March 16, 2017

Re: Public Version of the Comments on IPL's 2016 Integrated Resource Plan

**Figure 1. Slide 25, IPL October 21, 2016 Stakeholder Meeting: Base Case Capacity**

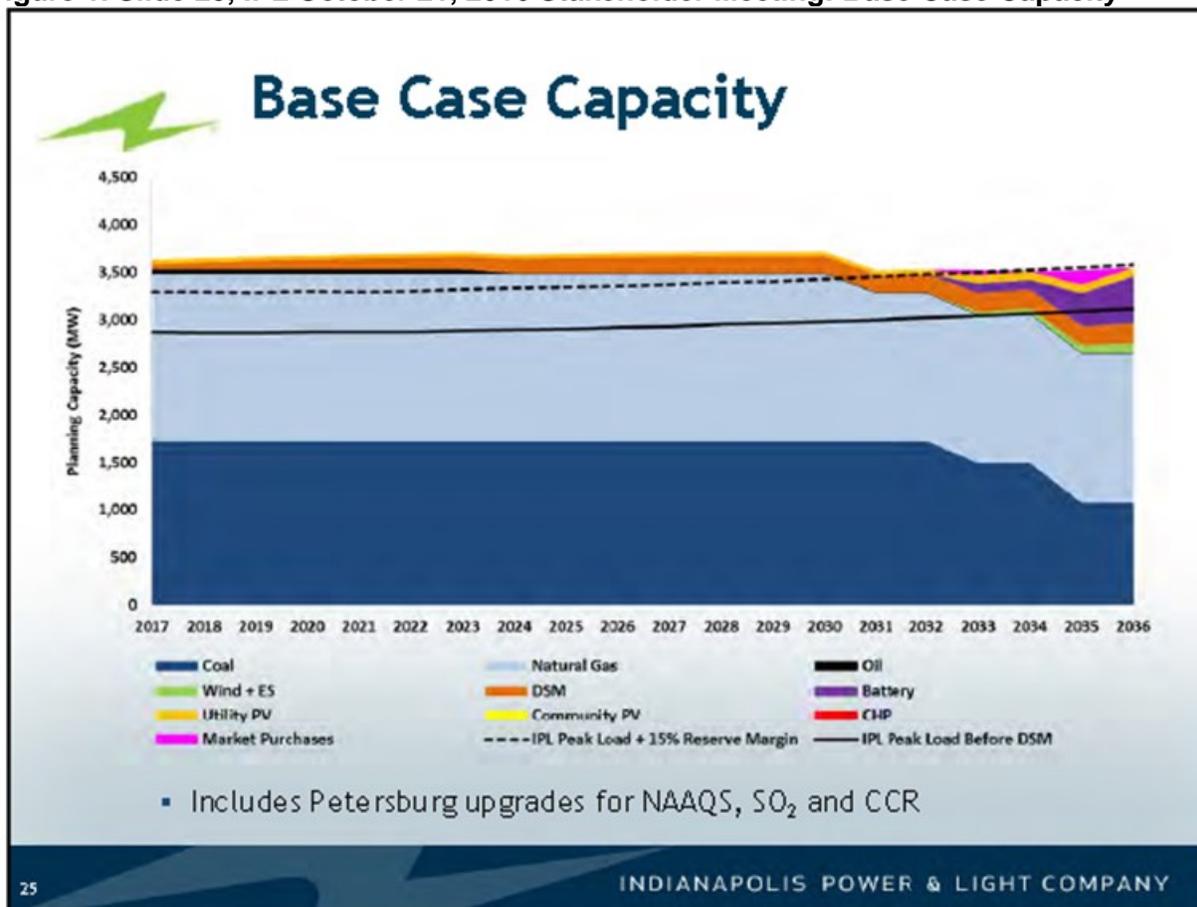
For example, when IPL showed the graph reproduced as Figure 1 below at its October 21, 2016 stakeholder meeting, the following information—critical to its accurate interpretation—was omitted: The black dotted line labeled “IPL Peak Load + 15% Reserve Margin” is not the reserve margin requirement that was actually modeled by ABB in IPL’s Base Case. The reserve margin requirement modeled by ABB incorrectly starts at a much higher percent for the first five years of the period before falling to 15 percent. This discrepancy helps explain the preponderance of excess capacity in this and the other scenarios in IPL’s 2016 IRP (see Section VII-B-1).

**Figure 2. Slide 37, IPL October 21, 2016 Stakeholder Meeting: Quick Transition Energy**

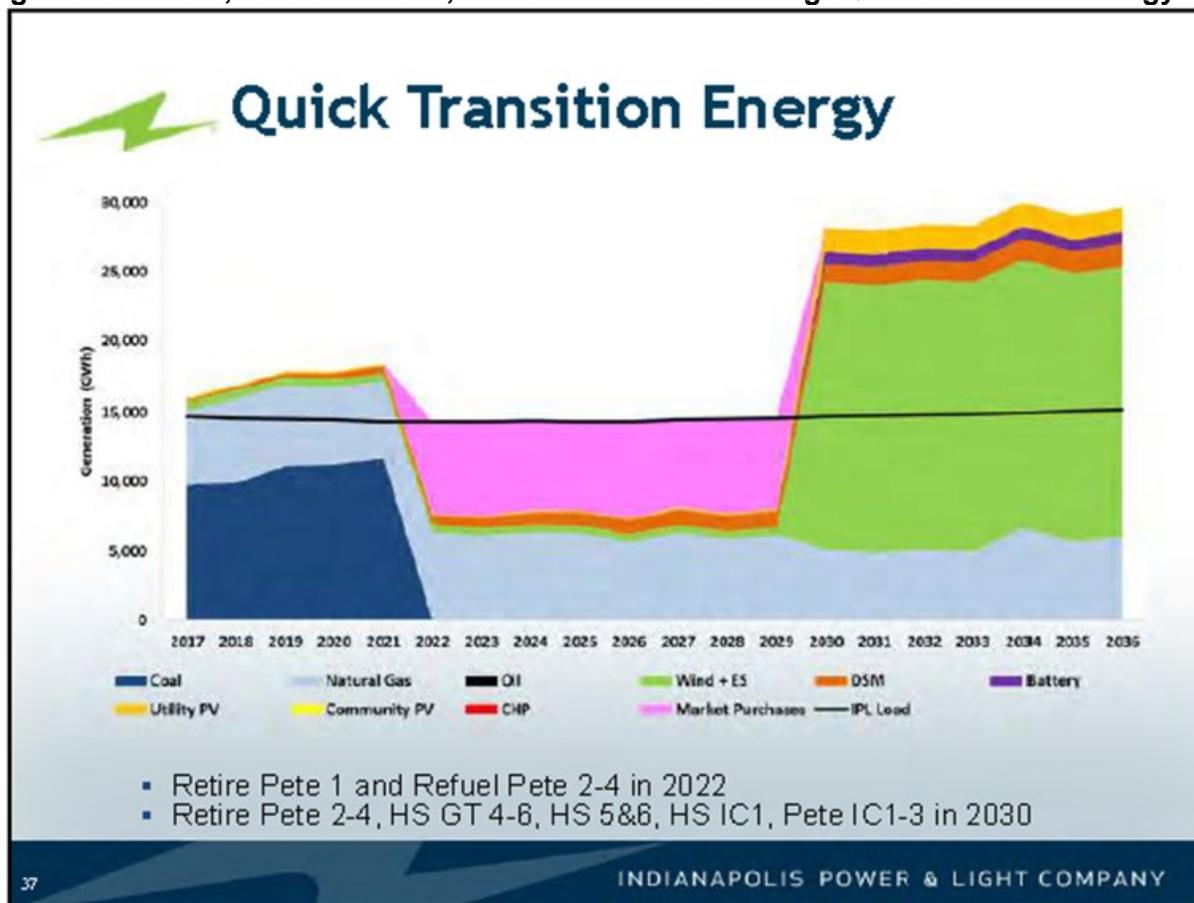
Similarly, when describing the energy mix of the “Quick Transition” scenario—reproduced below as Figure 2—critical information was again omitted. The IPL narrative states that: “In the Quick Transition scenario, the Capacity Expansion Model was directed to select all of the demand-side management (DSM) bundles that were available (19 EE bundles and 6 DR bundles in both

periods of interest).”(IPL 2016 IRP p.179), however, based on our review of IPL modeling files this resource portfolio *was not modeled* in Capacity Expansion.<sup>7</sup> Rather, it was designed and selected by IPL.

As we pointed out to IPL during the October 21, 2016 stakeholder meeting, the level of market energy purchases does not make sense because they are such a significant portion of total energy requirements, nor for that matter does the level of wind purchases late in the study period because they represent so much excess energy. IPL seemed to agree with the former, but declined to change its modeling to represent a more realistic scenario.<sup>8</sup>

**Figure 4. IPL 2016 IRP Executive Summary Figure E: Candidate Resource Portfolios (MW in 2036)**

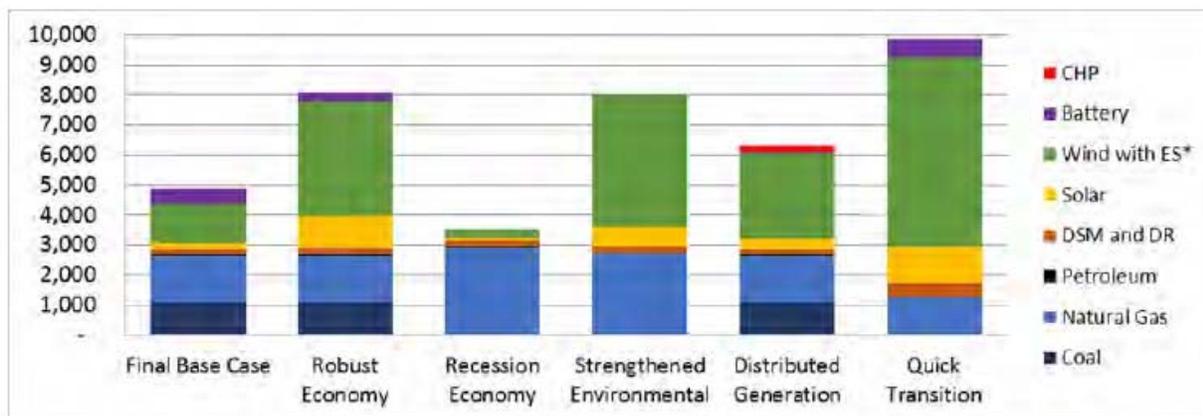
TVA's approach models each scenario with each strategy or set of resource options, for example, how Strategy A fairs under each of the 5 scenarios. IPL, in contrast, would model Strategy A only under Scenario 1. TVA's strategy makes it possible to evaluate whether a given portfolio fairs well under a variety of different possible futures and creates more meaningful apples-to-apples information. A utility's preferred resource plan should perform well under a variety of different scenarios or possible future outcomes. Using TVA's approach, extremes of non-base case scenarios do not force resource decisions that would not test well under base case conditions. Figure E of IPL's Executive Summary, reproduced as Figure 4, illustrates this.

The Robust Economy, Strengthened Environmental, Distributed Generation, and Quick Transition portfolios all have many more MWs of capacity than do the Final Base Case and Recession Economy portfolios. It would be reasonable to expect that the portfolios with more capacity would be more expensive.

**Figure 7. IPL’s modeled capacity needs in 2018 given various retirement assumptions**

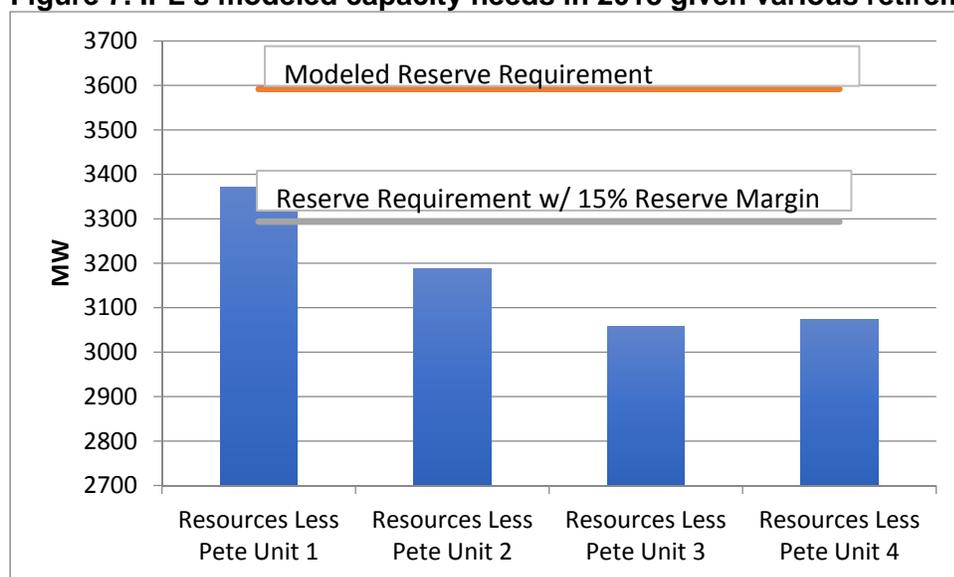
This is because, for example, since IPL modeled a reserve margin well above the actual required 15 percent MISO reserve margin, the Capacity Expansion model erroneously assumes that the retirement of Petersburg Unit 1 in 2018 would create a capacity need (see Figure 7 in Section IX and **Error! Reference source not found.** in Section XIV).

An error in the modeled reserve requirement is an additional source of bias against retirement with replacement by renewables. IPL’s modeled capacity need in 2018 with the retirement (individually) of each of the Petersburg units is presented in Figure 7 (where “Petersburg” is abbreviated as “Pete”). The orange/red line in Figure 7 is the reserve requirement as modeled by ABB for IPL and the green line is the reserve requirement using the correct 15 percent reserve margin requirement. If the correct reserve margin requirement had been used in IPL’s IRP modeling, Petersburg 1 could be retired in 2018 with no new resources added to replace it.<sup>17</sup>

**Figure 8. IPL’s DSM Technical, Economic, and Achievable Potential, 2018-2020**

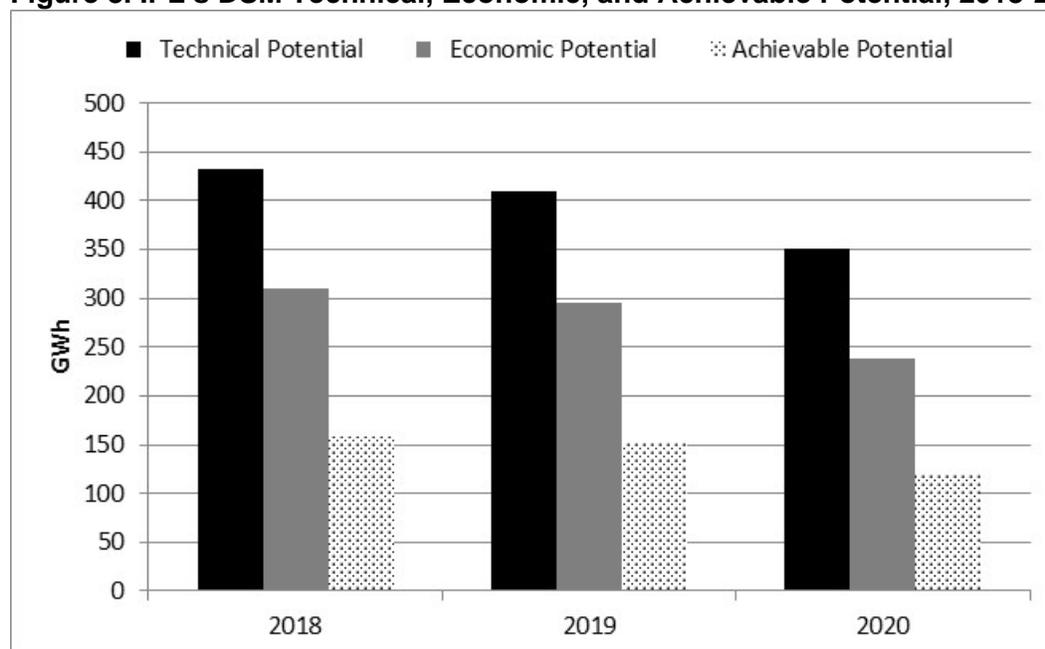
Third, IPL’s black-box assumptions about customer adoption rates contribute to a large drop in the 2016 IRP’s DSM potential from the economic to achievable categories as shown in Figure 8. In each of the years 2018 to 2020, 49 percent of DSM economic potential is eliminated in screening for achievable potential. Achievable potential represents, in part, the removal of current opt-out customers. But in 2018, for example, excluding those customers would remove just 5 percent of achievable potential.<sup>24</sup> The remaining difference between economic and achievable potential—a 44 percent reduction from economic potential—must therefore result from AEG’s adoption rate assumptions, for which IPL has provided reviewers nothing more than a spreadsheet with annual percentages.

**Figure 9. IPL 2016 IRP reserve resources and reserve requirement**

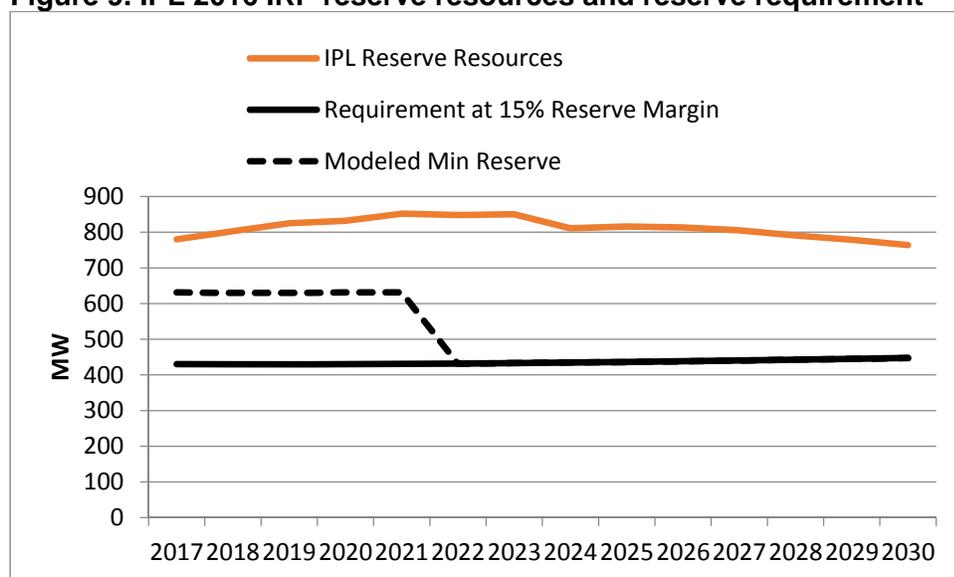
No, the IPL 2016 IRP preferred resource portfolio does not incorporate a workable strategy for reacting to unexpected changes in circumstances quickly and appropriately. One of the most significant decisions facing IPL is the question of whether to retire, retrofit, or refuel the Petersburg units. As discussed previously, because of the inflated reserve margin setting in the first five years of the planning period, as well as the limited resources available before 2019, IPL’s model output in any scenario is highly unlikely to reflect the most “economic” choice. Once these units are retrofitted, there is no “flexibility” in IPL’s plan, and their continued operation puts IPL in a significant excess capacity position for years to come as shown in Figure 9.
